TECHNICAL NOTE

Fewcott Road, Fritwell

Job Number: J323847	Date: 30 September 2019	Client: CALA Homes (Chiltern) Ltd
Prepared By: MF	Approved By: BF	Ref: 19/00616/OUT

Site Access Appraisal

F	27-09-19	Amended
E	06-08-19	Amended
D	27-06-19	Amended
C	11-06-19	Amended
B	31-10-18	Amended
A	08-10-18	Issued
drawing no.		J32-3847-PS-001

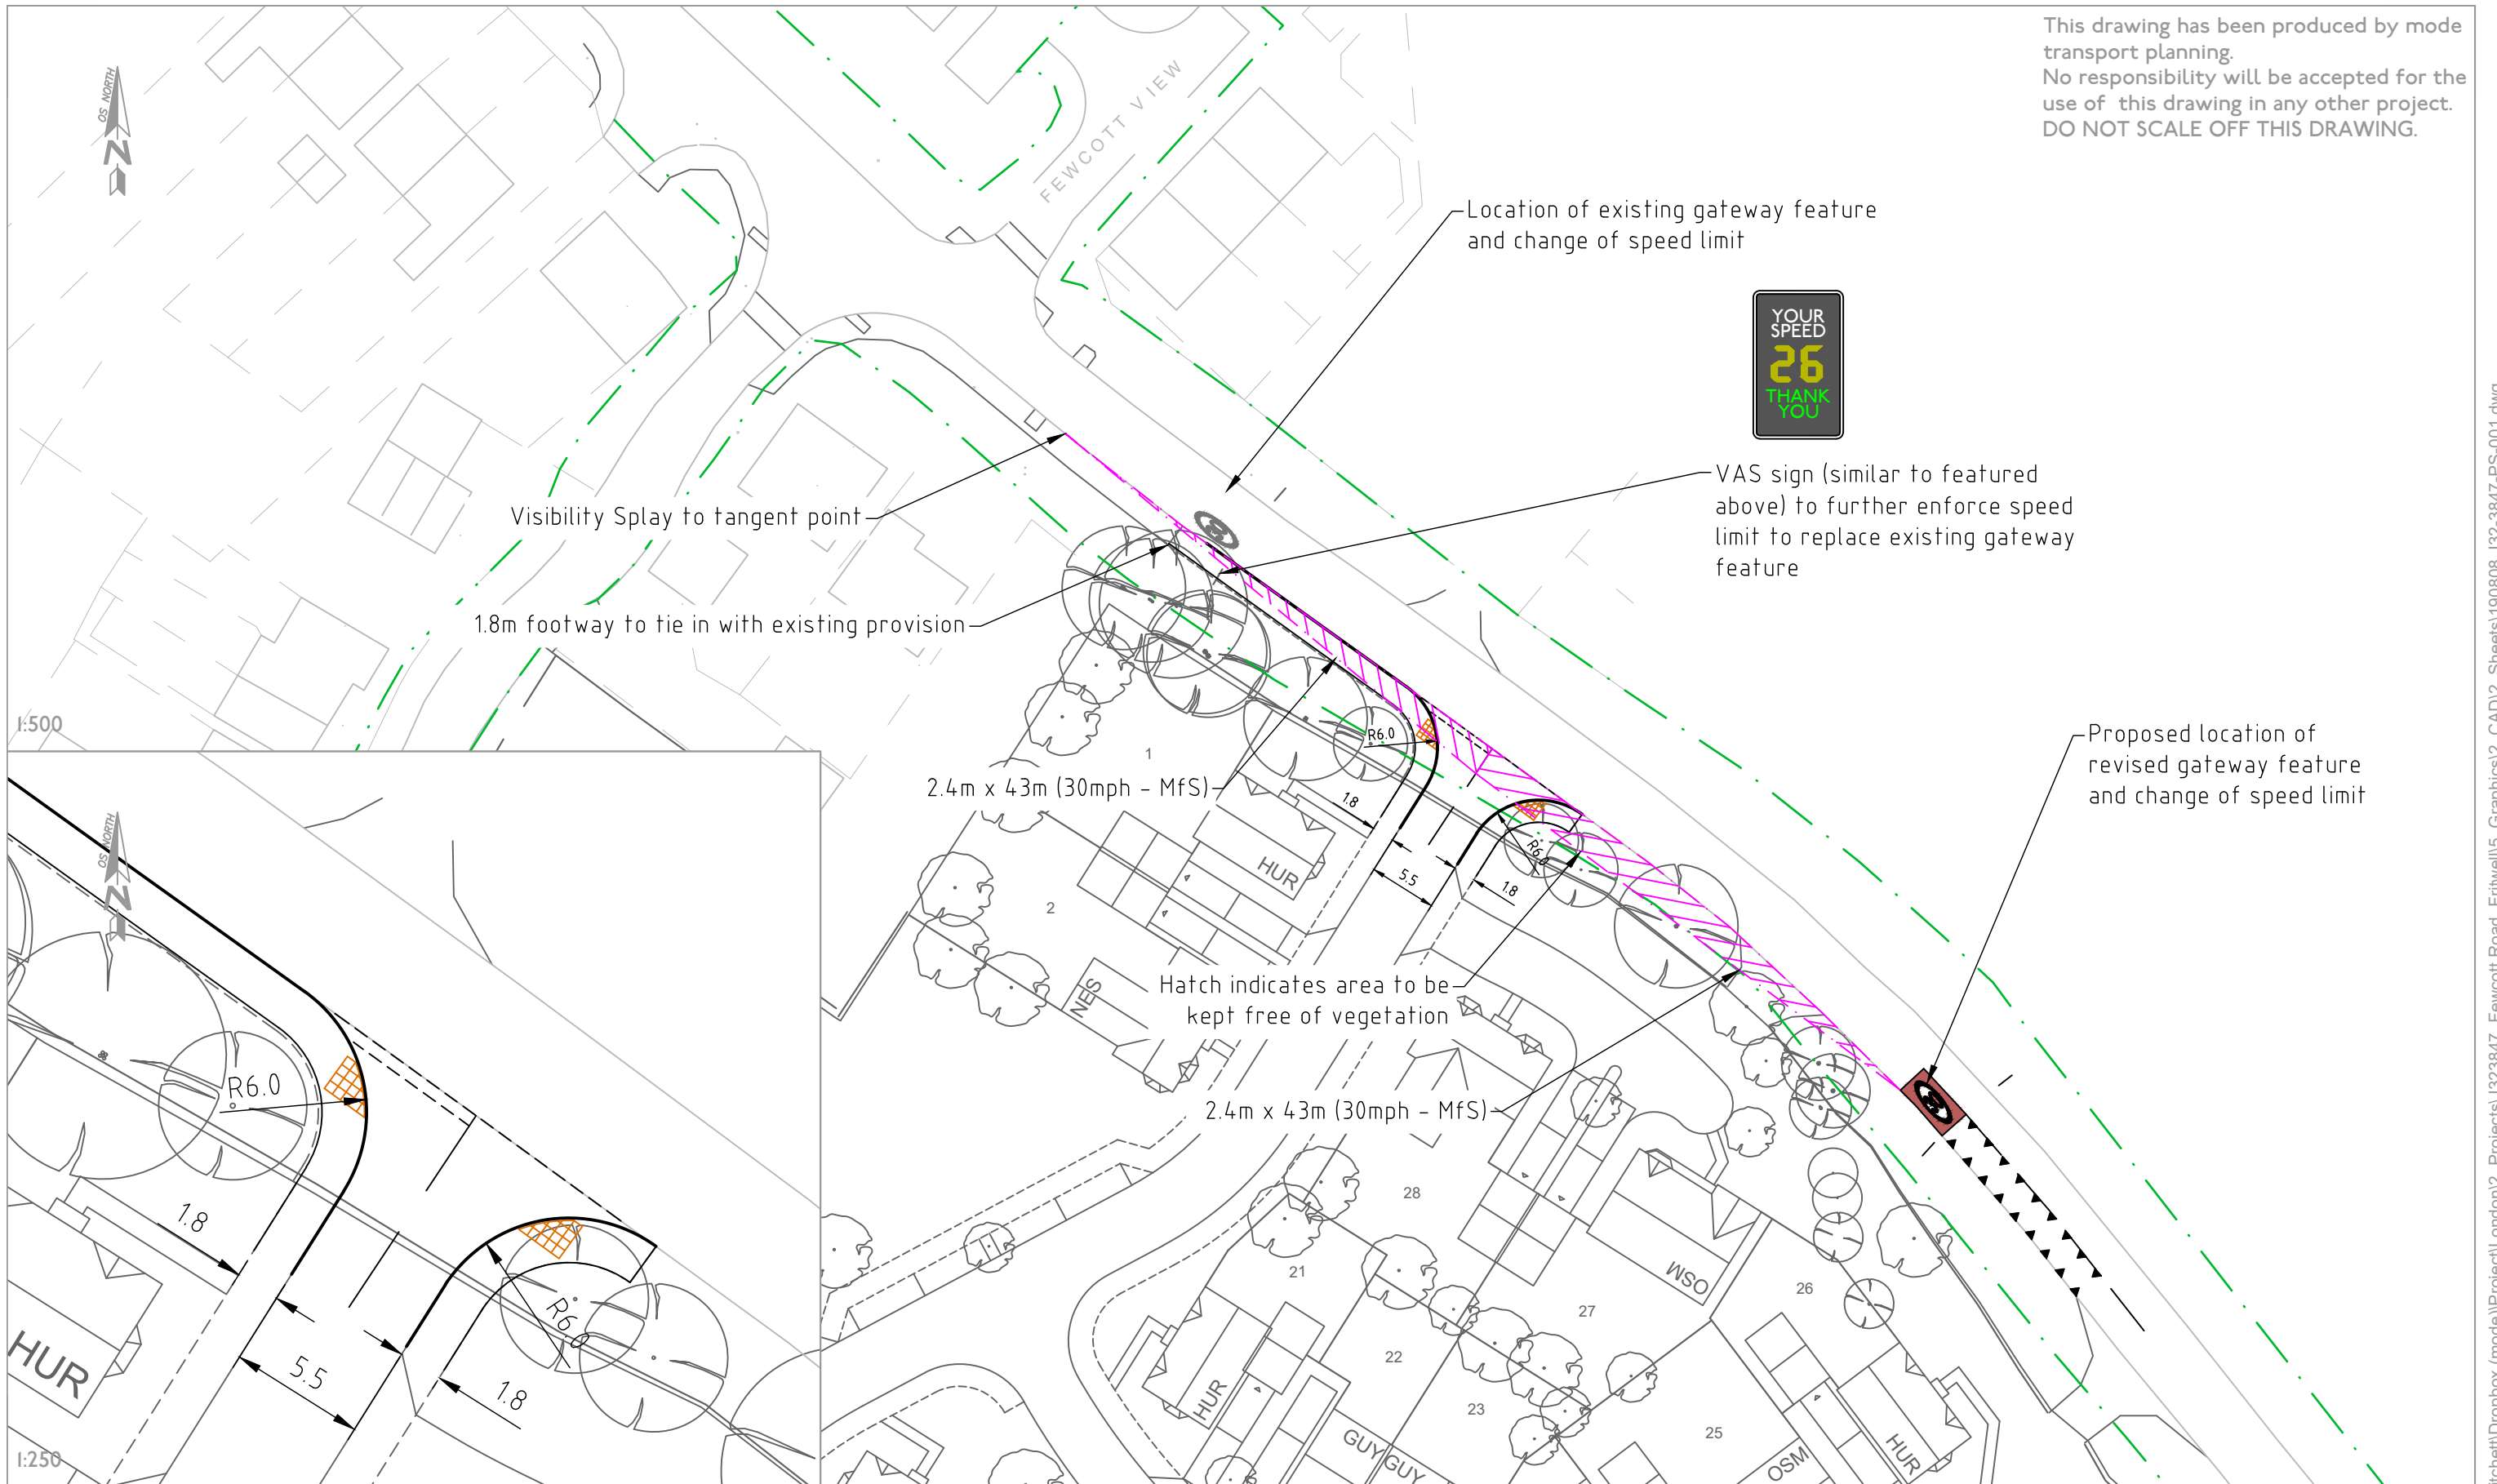
- 1.3 A summary of the OCC comments is provided below, with a full copy of the comments appended to this note as **Appendix B**:
 - Achievability of the visibility splays at the proposed site access relative to the posted speed limit;

- The applicant has shown that visibility splays of 2.4m x 215m can be achieved at the proposed site access, however, there is a planting in areas which does not appear to be within the site boundary or publicly maintained land. There are therefore no assurances that the visibility splay can be maintained.

Following comments from previous application 16/01594/F which stated that due to the fact that the reduction in speed limit required consultation and cannot therefore be certain, the applicant must show that the visibility splays must be based on 60mph. The access has been moved slightly towards the village and visibility splays of 2.4m x 215m have been provided, however, the splay goes across land which is not dedicated as public highway and does not fall within the site boundary.

As neither the applicant or the county council have control of the planting in this area, adequate visibility cannot be achieved and as such safe and suitable access into the site cannot be achieved. As such, Oxfordshire County Council recommend refusal on highway safety grounds.

- The speed limit should be extended approximately 160m minimum out of the village to allow for the whole site frontage to be included within a 30mph limit and ensure adequate vis splays are provided. As there is no certainty this will pass consultation, visibility splays showing 215m are required.

- 3.1 The proposed development will be served via an access off Fewcott Road, approximately 50m north of the existing agricultural access to the site.
- 3.2 This new access has been designed in accordance with the design principles for a 'Minor Access Road' within the guidelines set out within the OCC Residential Road Design Guide (2003) - Second Edition (2015), and the guidelines set out in Manual for Streets (MfS). The proposed access arrangements are shown in **Drawing J32-3847-PS-001 (Rev F)**.

- 3.3 The access strategy includes:
 - Providing a 5.5m carriageway width for the access to the site, with a 1.8m footway (both sides of the carriageway);

- Provide 6m entry radii at the site access; and,
 - To extend the footway from the site along Fewcott Road to connect with the existing footway provision within Fritwell, providing a 1.8m width pedestrian link for the development proposals.

- 4.1 The visibility splay requirements for the proposed site access have been considered based upon both, 30mph speed limit which we are extending as per the proposals to relocate the village gateway feature and in line with the recorded vehicle speeds as described in **Section 2** of this note to provide a robust assessment
- 4.2 Horizontal visibility splays, in line with the relocation of the gateway feature and 30mph speed limit, have been based on the standards within MfS, which require a visibility splay of 43m in both directions to be achieved from a setback distance of 2.4 metres.
- 4.3 MfS standard visibility splay assessments are shown to be achievable in **Drawing J32-3847-PS-001 (Rev F)**. The splays can be delivered in either land in the control of the applicant or within the adopted highway boundary.

- Horizontal visibility has been demonstrated in **Drawing J32-3847-PS-001** to be achievable in both directions in accordance with MfS requirements;
- The OCC standard refuse vehicle can access and egress from the proposed site access, as show in **Drawing J32-3847-PS-006**;

scale	Varies@A3		
drawn	jwm	C	18-09-19
checked	mf	B	26-07-19
created	Nov '18	A	08-11-18
drawing no.		J32-3847-PS-006	
		Amended Amended Issued

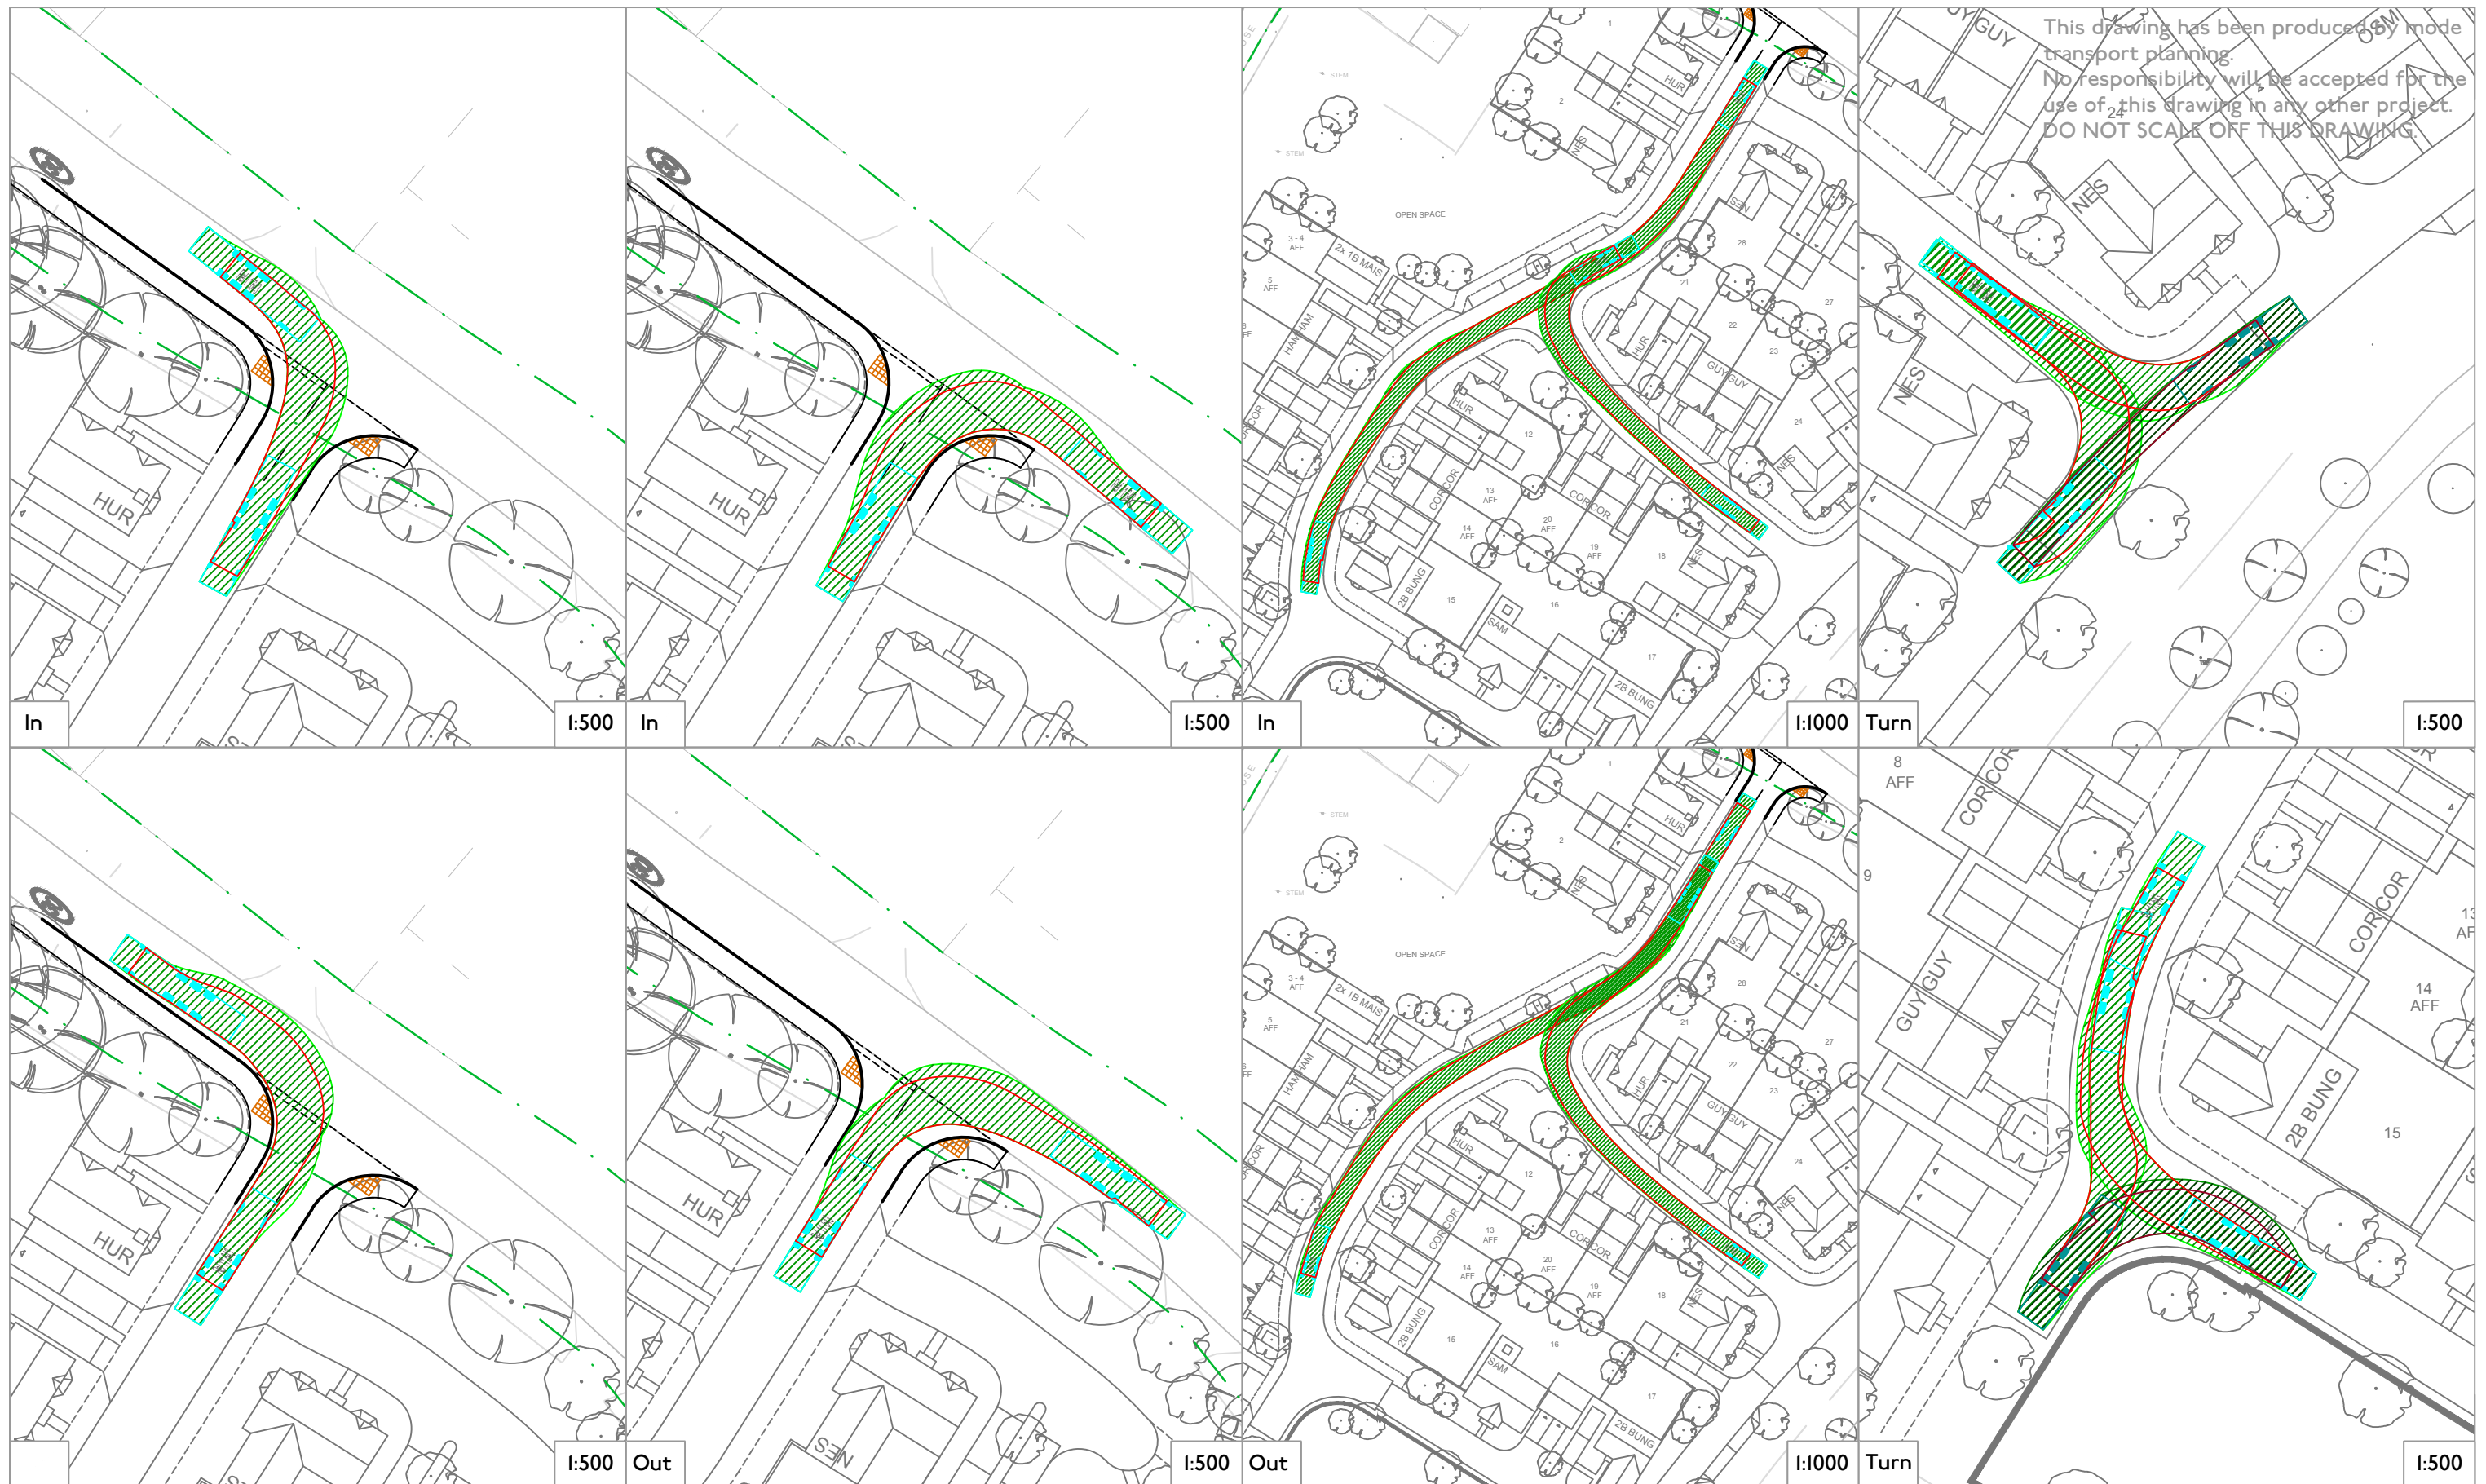
- Confirmation of on-site carriageway widths and refuse vehicle tracking;
 - Proposed parking numbers in line with OCC parking standards; and,
 - Deliverability of the proposed footway on Fewcott Road, of minimum 1.5m width, linking with existing footway provision.

- On-site carriageway widths are insufficient and will need to be widened in order to allow to 2 vehicles to pass whilst allowing adequate space for pedestrians. Space is also needed to allow refuse/servicing vehicles to pass cars parked on the carriageway which is likely to occur if further parking provision is not added.

- Tracking needs to be carried out with the below vehicle details
OCC require a swept path analysis for refuse vehicle for all manoeuvres in forward gear. All internal bends and junctions will need to be tracked with two vehicles (refuse vehicle and medium sized car) using the bend/junction at the same time.
Phoenix 2 – 23W with elite 2 6x4 chassis
Dimensions;
Overall length – 11.6m (including bin lift)
Overall Width – 2.530m
Overall body height – 3.205m
Min body ground clearance – 0.410m
Track width – 2.5m
Lock to lock time – 4.00s

- 5.2 Nonetheless, and in accordance with OCC guidance, a swept path analysis has been undertaken using an OCC standard refuse truck (11.643 metres in length) to ensure that it can access/egress the site. The refuse truck represents the largest vehicle that would be expected access to the site (including emergency vehicles).

- 5.3 **Drawing J32-3847-PS-006 (Rev B)** demonstrates that the design vehicle can access and egress the site but would be required to use the whole width of the carriageway. Given that refuse collection is infrequent, typically carried out outside of peak times, traffic volumes on this section of carriageway have been demonstrated to be low in the submitted Transport Statement and the access and internal road layout have been designed in line with OCC guidance, this is considered acceptable.
